BLOCK A

May 16 Design Review

DESIGN REVIEW SUMMARY

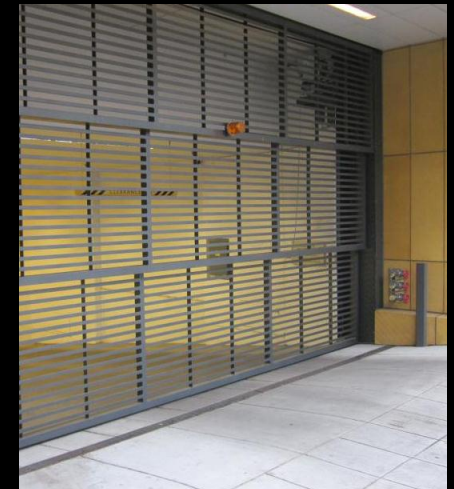
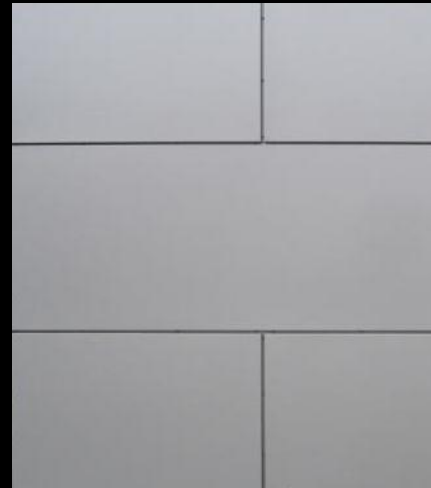
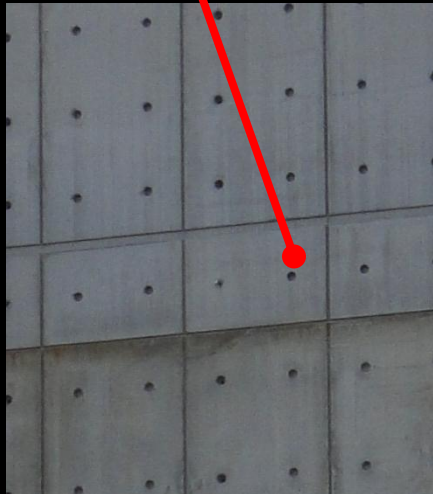
1. Ground floor Windows – CIP vs. Board-formed Concrete

2. Quality of Materials:
 - Fiber cement board
 - Rigidity of Metal Panels
 - End Walls at the property line
 - CIP on Multnomah

1. ELEVATION - SOUTH
SCALE: 3/32" = 1'-0"

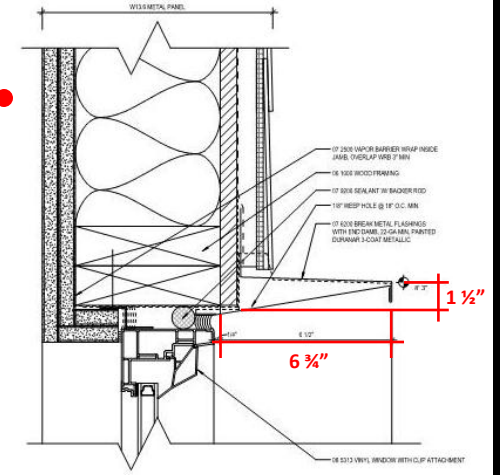
STAFF CONCERN ABOUT C.I.P.

CANOPIE DETAILS

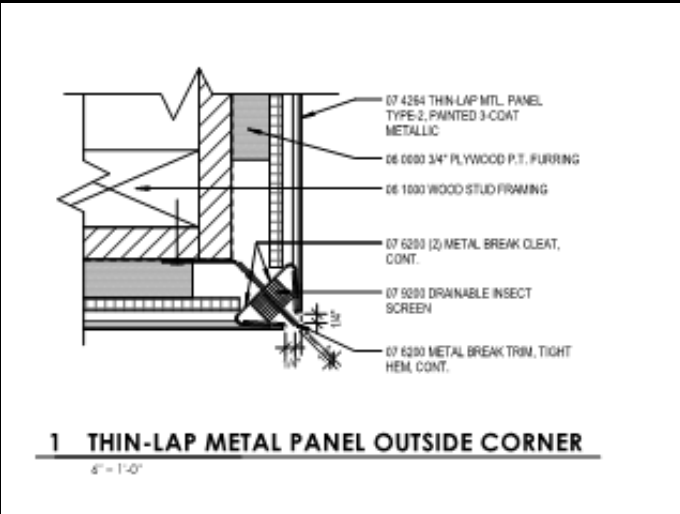
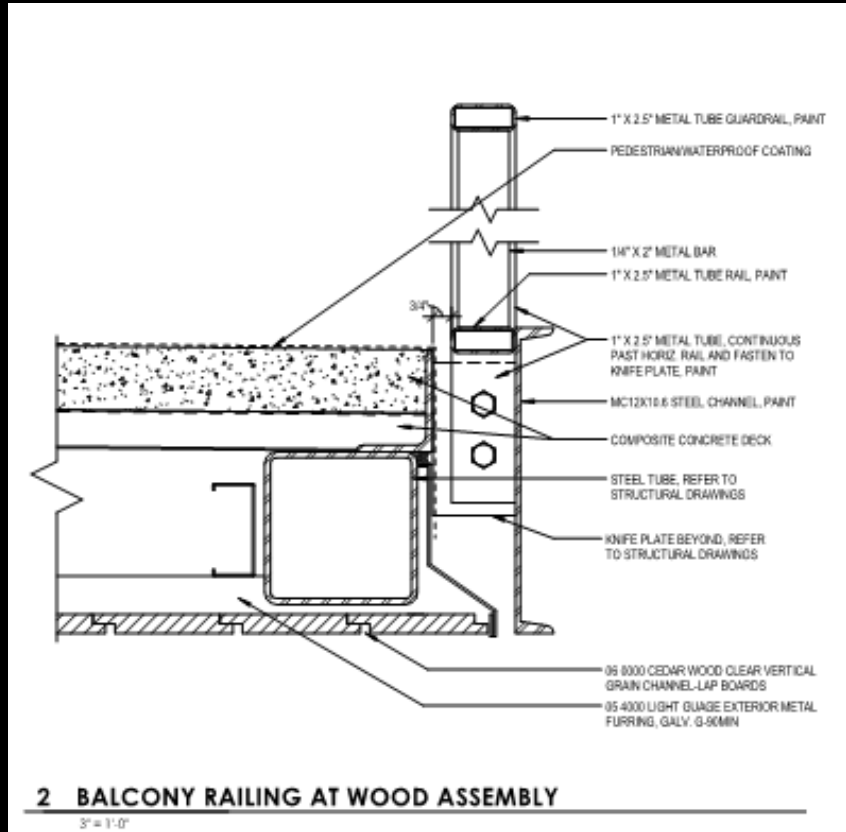
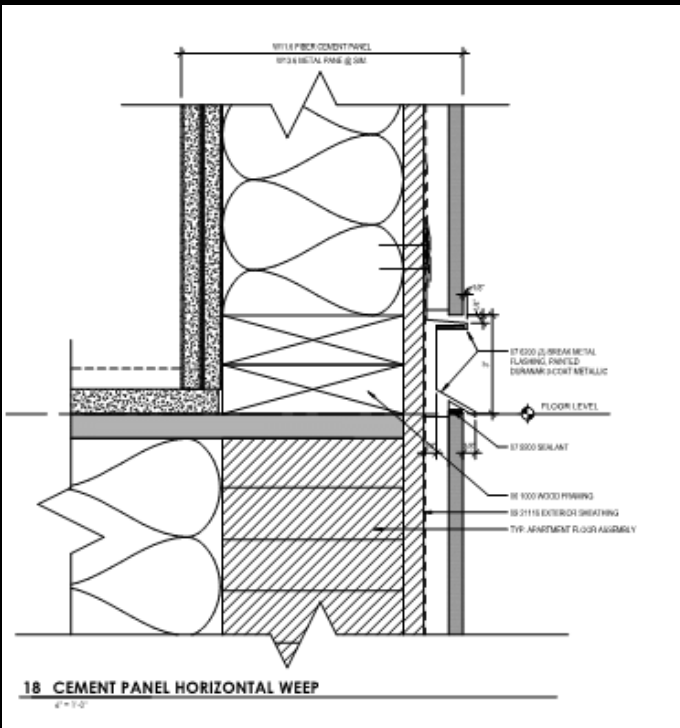
UPDATED: ANGLED SURFACE
AND THIN FLUSH STRIP LIGHTS,
REFERENCE RENDERING

BLOCK A - PLAZA

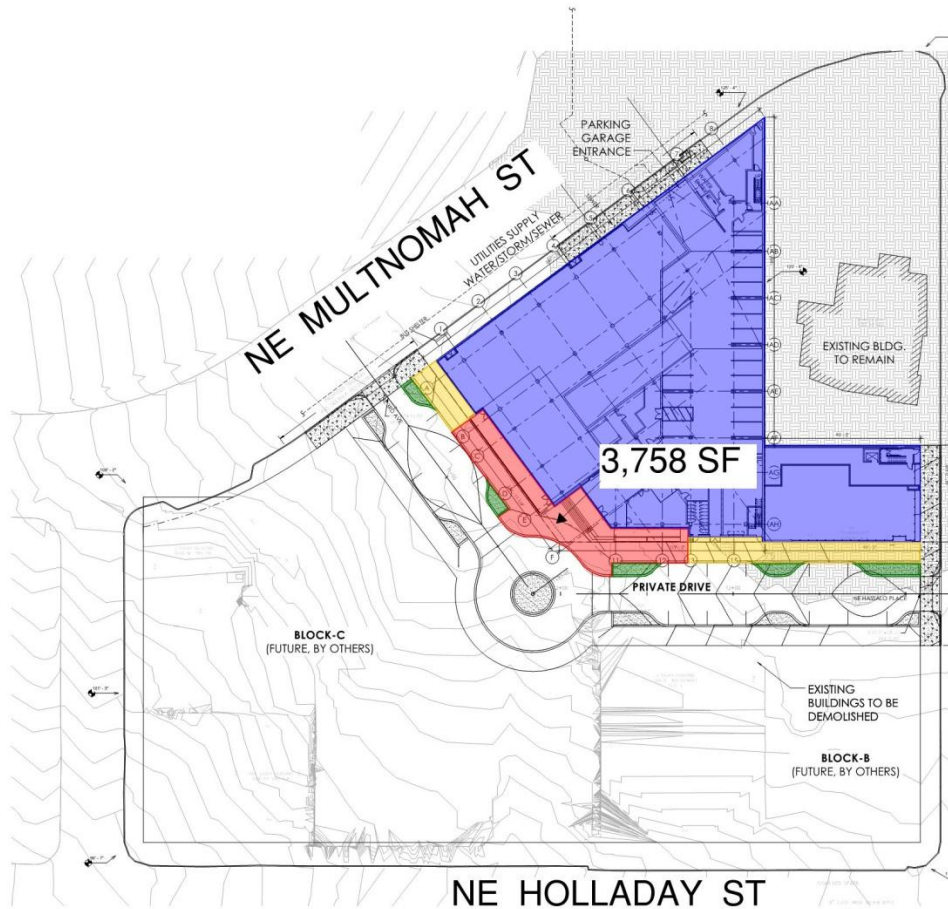
MEANINGFUL NATURE OF PLAZA SPACE

To promote a pleasant and convenient walkway and open space system on the superblock that links to the adjacent buildings, to the public circulation system and to available public transit. The requirements also promote the maintenance of light, air and access that could be lost due to development on the vacated street.

MEANINGFUL NATURE OF PLAZA SPACE

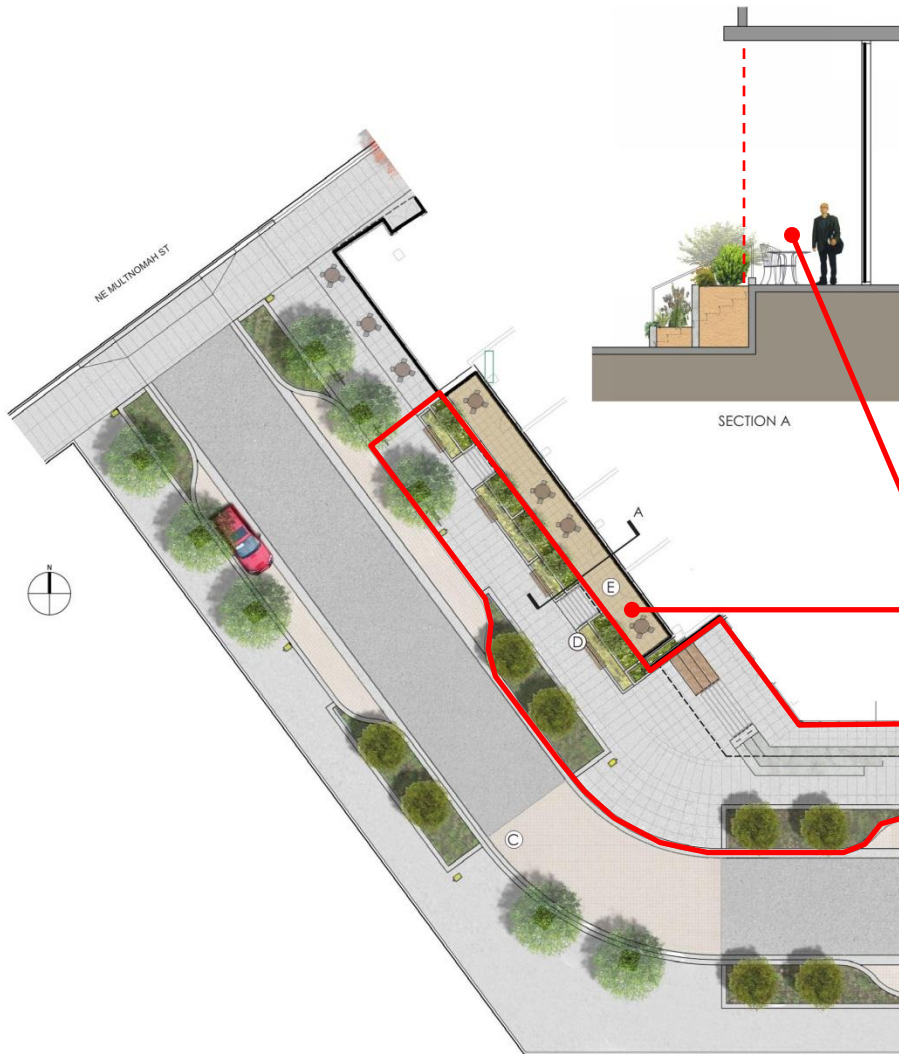
DAR DISCUSSION OF PLAZAS

1. The requirement for a plaza seems antiquated and like an old way of thinking about good active urban space that we have since come a long way from
2. The plaza should create a node in a series of connections and the proposed design meets that intent.
3. A series of plazas is better than one (plaza) in the middle of something long.
4. Consensus that the approach was a great approach to resolving the requirement and better meets the intent of the code.
5. Concern about seating areas not feeling public on the front porch of the retail or the sidewalk seating feeling like it belongs to the retail and is not public.
(now housing and private front porch is not counted)
